SYSTEM/MODEL: TD-H/B

MODIFICATION: Eliminate pre-tone when paging is activated

## **ELIMINATE PRE-TONE WHILE PAGING**

TD-H/B Mod. #1298-1066 Sch #978-1066

## **PD-1 Schematic Diagram**

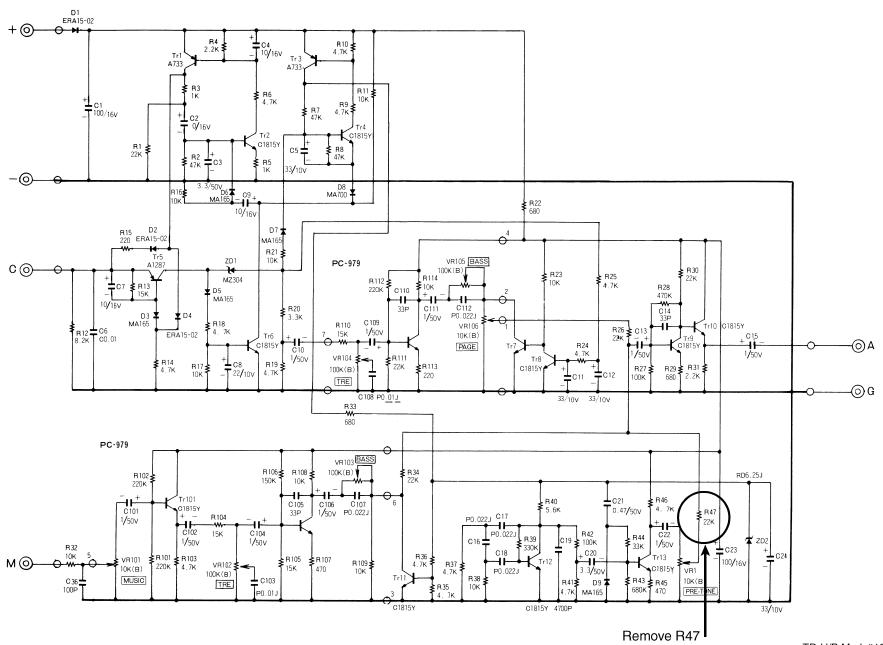
INSTR/OPERATIONS: 1. Remove R47 from PC-978 inside PD-1.
